ADDENDUM 1

DATE: May 25nd, 2018
 PROJECT: MSB Penthouse AHU Replacement
 ITB NO: 744-R1816 MSB Penthouse AHU Replacement
 OWNER: The University of Texas Health Science Center at Houston
 TO: Prospective Proposers

This Addendum forms part of and modifies Proposal Documents dated, April 27th, 2018, with amendments and additions noted below.

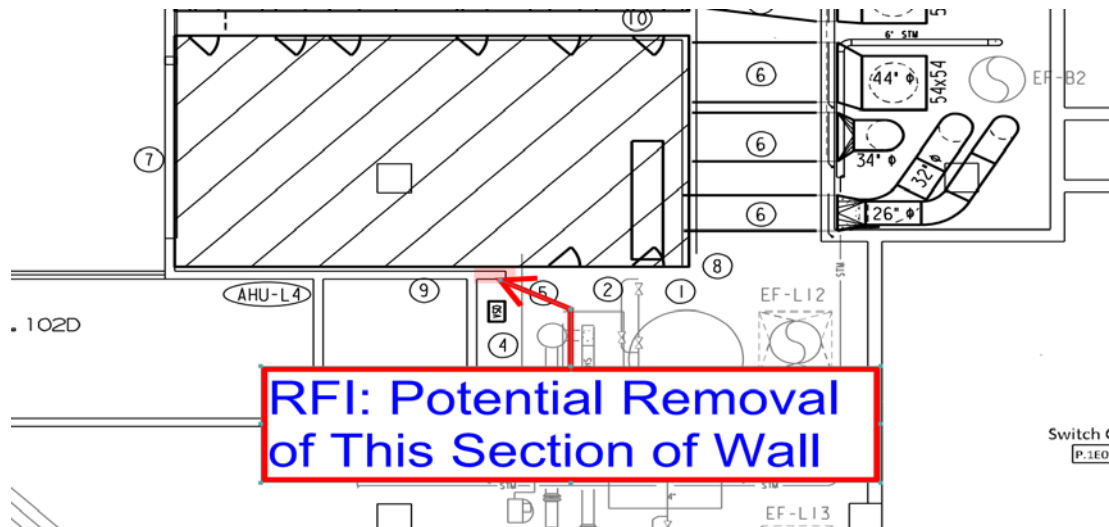
40.		M318	Would it be possible to eliminate the shaded section of wall in the drawing below to facilitate the location of the cooling coil condensate exit from the unit, and the condensate collection/reclamation tank?	Do not remove.
